ATTACHMENT A

Revised Pages of Technical Specifications.

Proposed Change No. 8
October 16, 1971

Figure 3.12-1 Limits for Poison Slug Worth

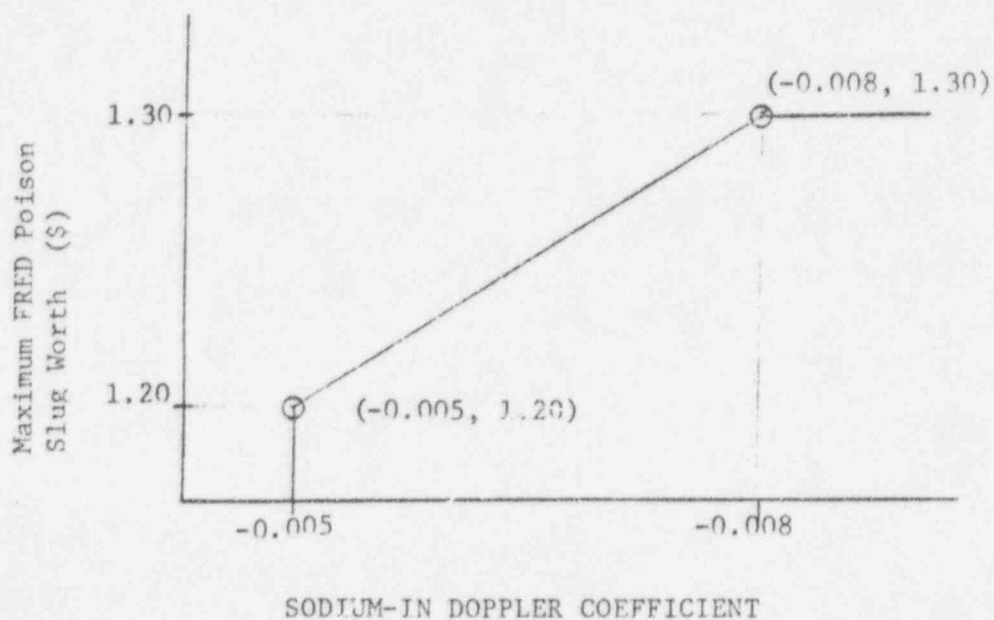
- a. The worth of the poison slug used in the prompt critical tests shall be equal to or less than 1.3\$ if the nominal value of the magnitude of the sodium-in negative Doppler coefficient ($T \frac{dk}{dT}$) is equal to or greater than 0.008. ~~The worth of the poison slug shall be equal to or less than 1.2\$ if the nominal value of the magnitude of the sodium-in negative Doppler coefficient ($T \frac{dk}{dT}$) is less than 0.008. If the nominal magnitude of the sodium-in negative Doppler Coefficient is less than 0.008 the worth of the poison slug shall be equal to or less than the value determined from the linear relationship in Figure 3.12-1.~~
- b. The initial reactor power level for prompt critical tests shall not exceed 11 MWt.
